**ADDENDUM NUMBER ONE
SECTION 00 91 13 (A)**

**PROJECT: REPLACE HAIL-DAMAGED ROOFS
JACKSON, HINDS COUNTY, MISSISSIPPI**

**PROJECT NUMBER: MEP-5000-25(080) 502884
MEP-5000-25(088) 502884**

| WORKING NUMBER: A3.3-ML | SHEET NUMBER: 12 |

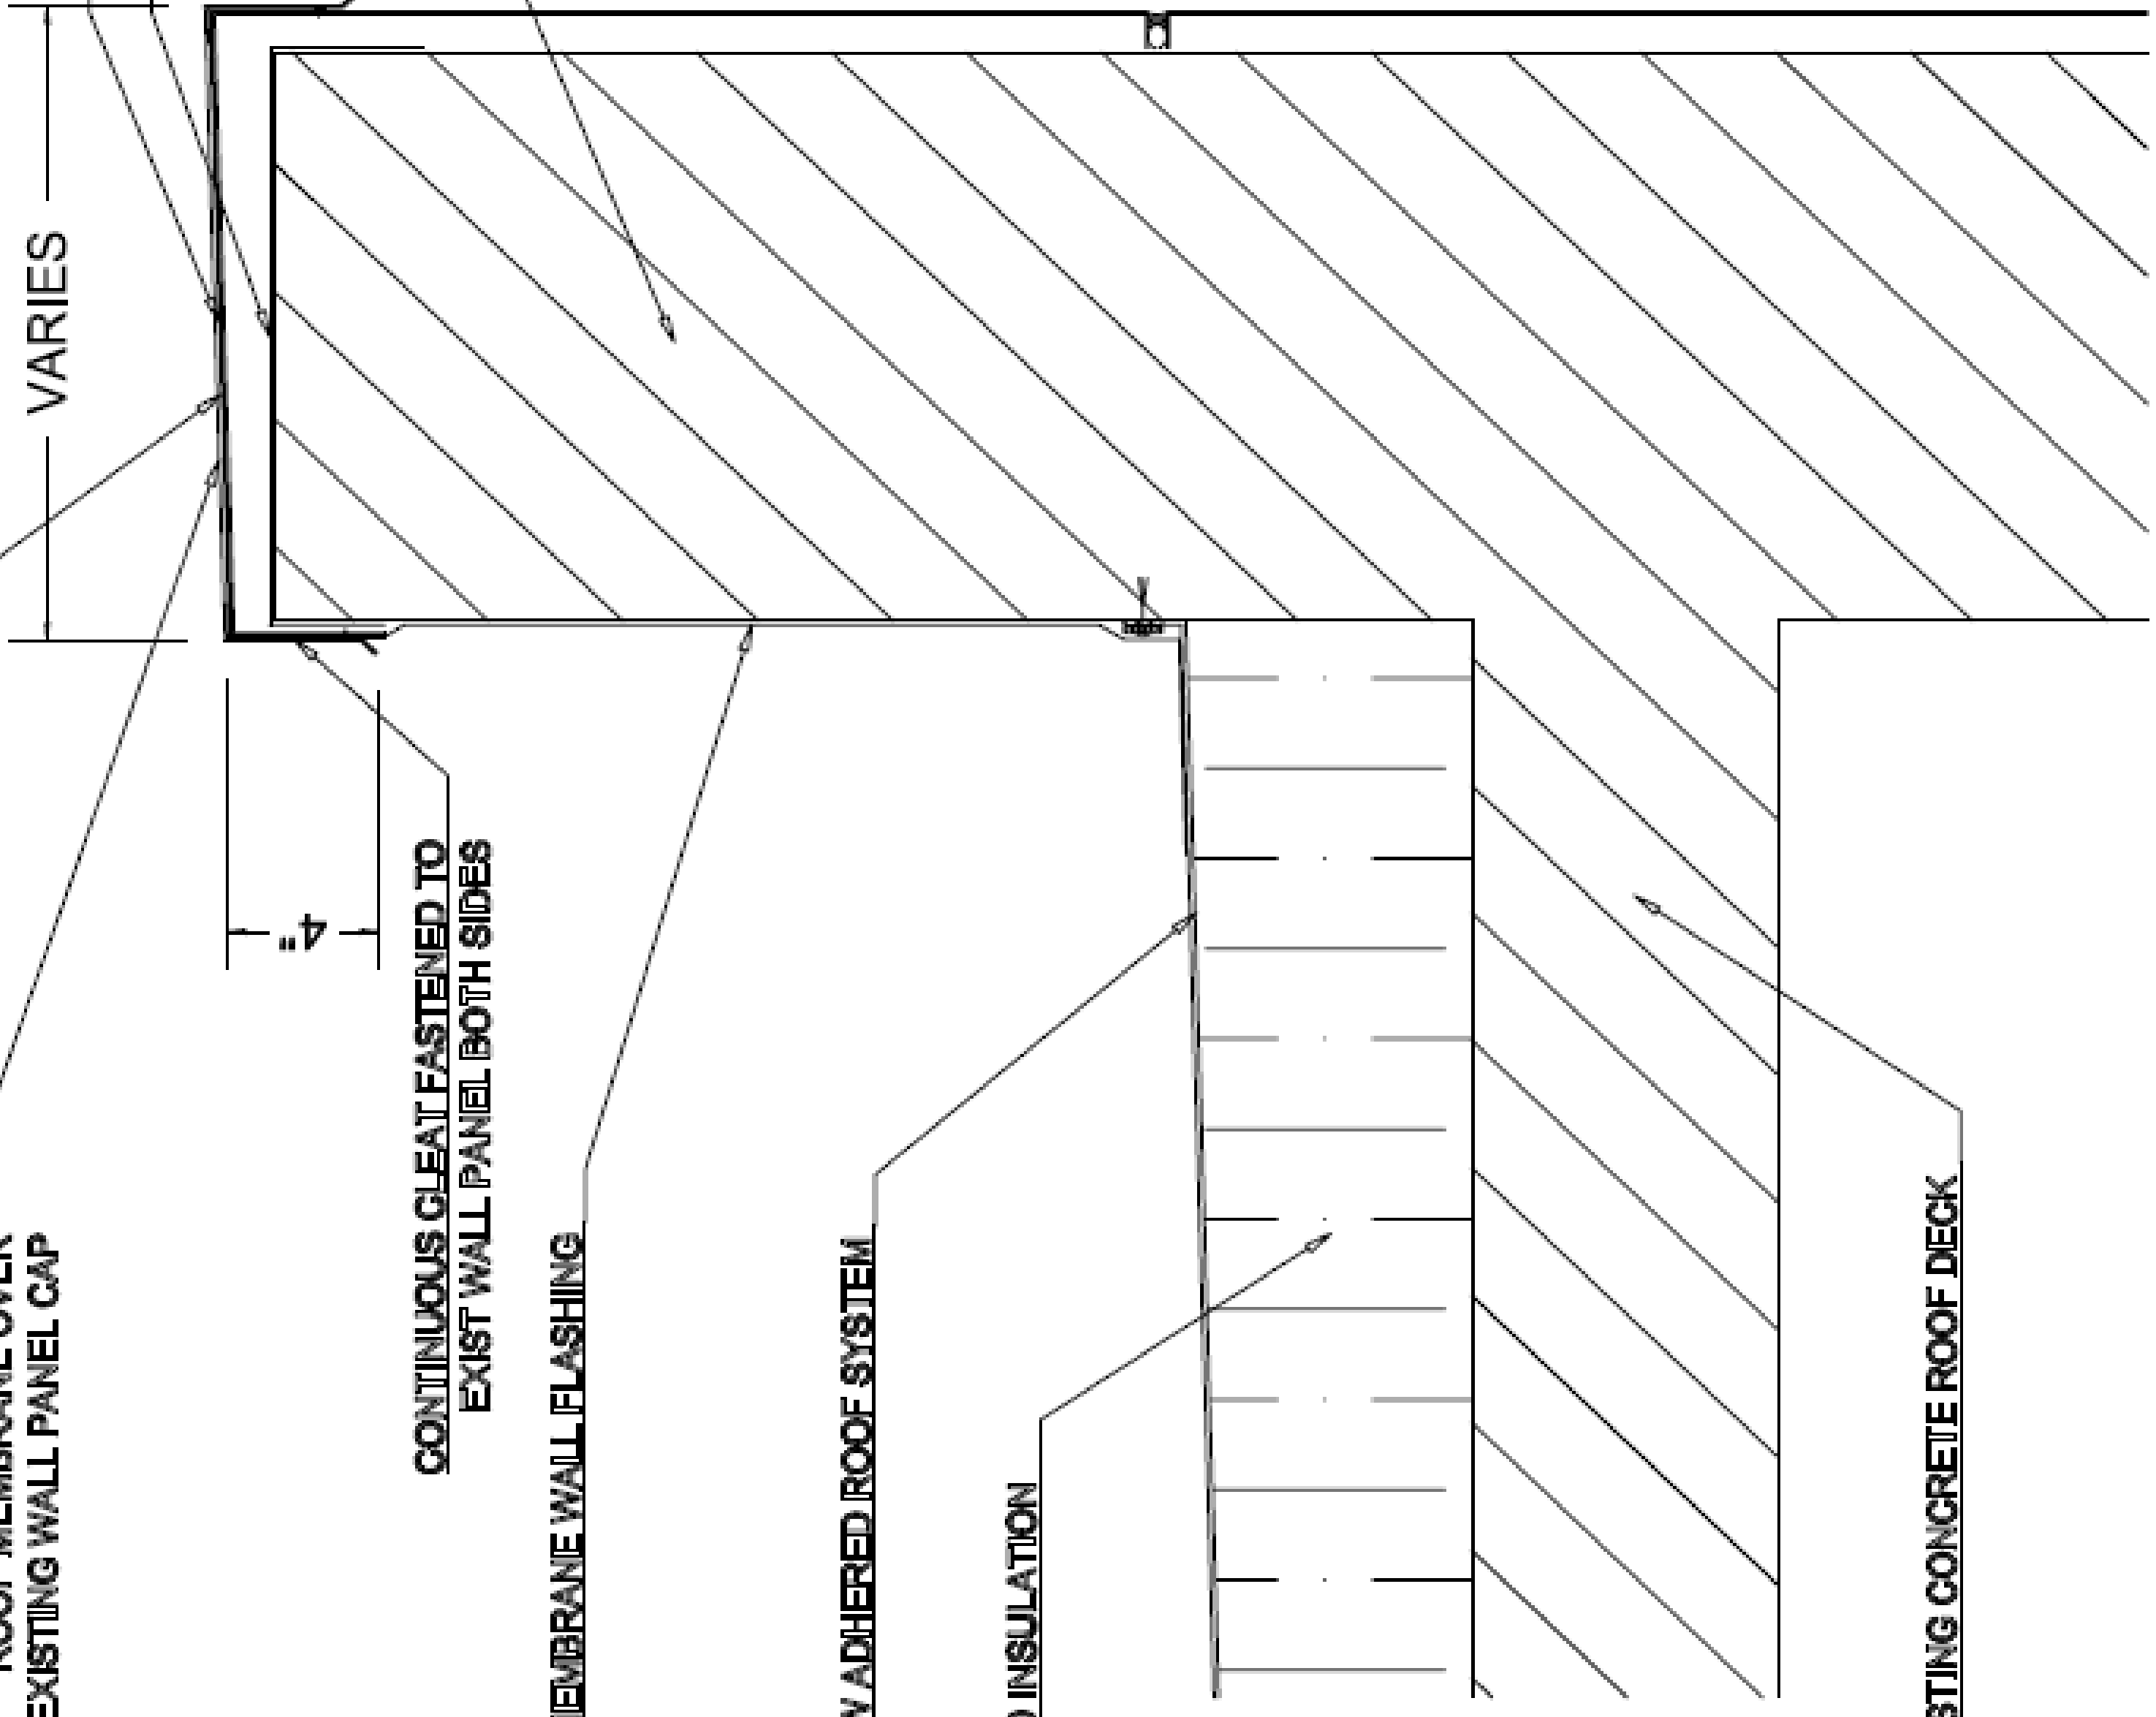
ADDENDUM
